City of Portland, Oregon
Bureau of Development Services
Land Use Services
FROM CONCEPT TO CONSTRUCTION

NOTICE OF A TYPE II DECISION ON A PROPOSAL IN YOUR NEIGHBORHOOD

CASE FILE NUMBER: LU 21-027966 AD

Proposal: The applicant proposes to construct a detached accessory structure with a garage on the main level and an accessory dwelling unit on the second level. The structure will be located behind the house on this 5,000 square foot corner lot, with the garage entrance access at SE Henry Street. Garage entrances must be set back at least 18 feet from the street

1 SITE PLAN

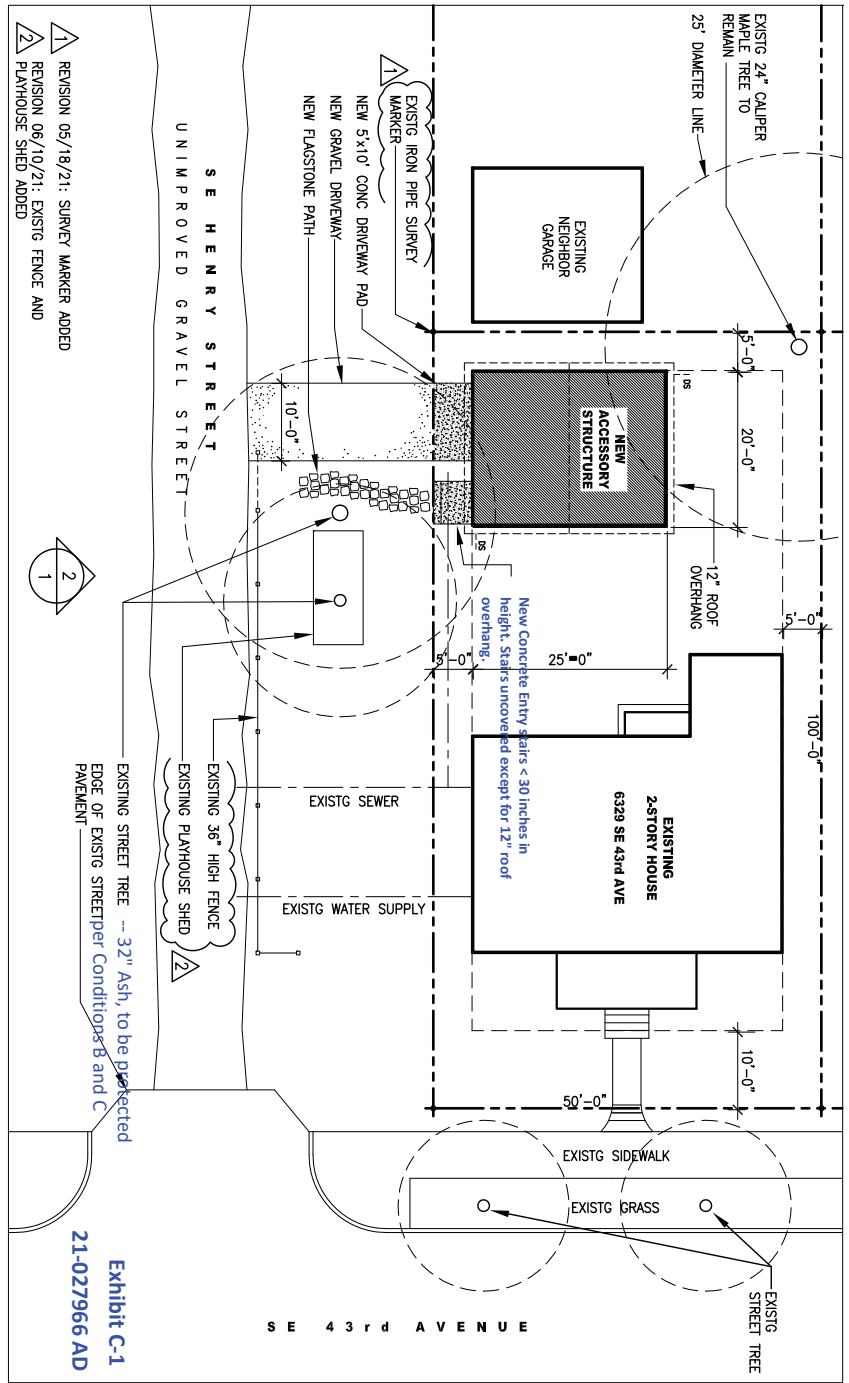
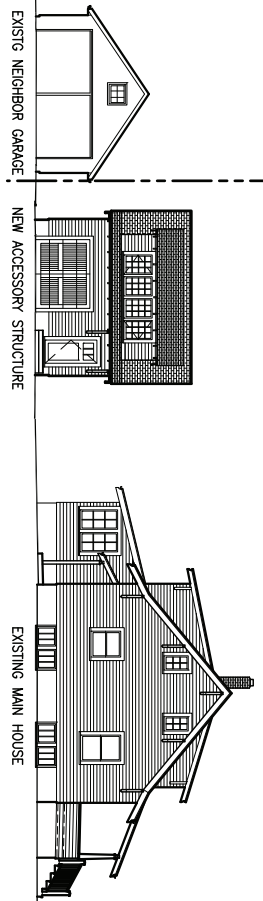
I have reviewed the Tree Protection Plan, Arborist Report, and other materials provided, and revisited the site. I am satisfied with the investigative work performed and the overall Tree Protection plan. My one concern is that the Arborist says, "If necessary, the proposed driveway should be designed to rest on top of existing grade to avoid the need to excavate and prune any roots." I am bothered by the "if necessary..." part because the point of this venture was to determine if other measures would be necessary. Because there is at least one root discovered within the new driveway foot print I feel that it is necessary to design in such a way that can best preserve tree roots. I would like to have required as a condition, that the driveway is to be built up, rather than excavated, and that the driveway must be constructed with 4"-6" of crushed rock over geotextile fabric to spread the load over potential tree roots. Also, it would be good to include the following boilerplate language:

. . . whether the location of the garage door will encourage vehicles to park in front of the door in a manner that would block the sidewalk and extend into the abutting roadway. However, at this location, SE Henry St - which is underimproved with an approximate 13-ft wide gravel roadway within a 60-ft wide ROW with no curb or sidewalk – has an existing fence and structure placed within the ROW which has the potential to block visibility and limits maneuverability within the ROW. City records indicate the applicant has not obtained an Encroachment Permit for the aforementioned fence and structure placed within the ROW.

- B. The Arborist's Report (Exhibit A-4) and recommendations must be part of the building permit plans and implemented on the site with the following additional requirement: To spread the load over potential tree roots, the driveway must be constructed with at least 4 inches and no greater than 6 inches of crushed rock over geotextile fabric.

- C. Additional inspection by and consultation with the Urban Forester is required prior to cutting street tree roots. Contact Urban Forestry (<https://devhub.portlandoregon.gov>) once roots are exposed.

- D. At such time that SE Henry Street is improved partially or fully to City standards, vehicles are prohibited from extending across or blocking the sidewalk or pedestrian corridor.

- E. The existing fence and shed within the SE Henry right-of-way adjacent to the site must be removed or an Encroachment Permit must be obtained through PBOT, prior to issuance of the building permit plans.
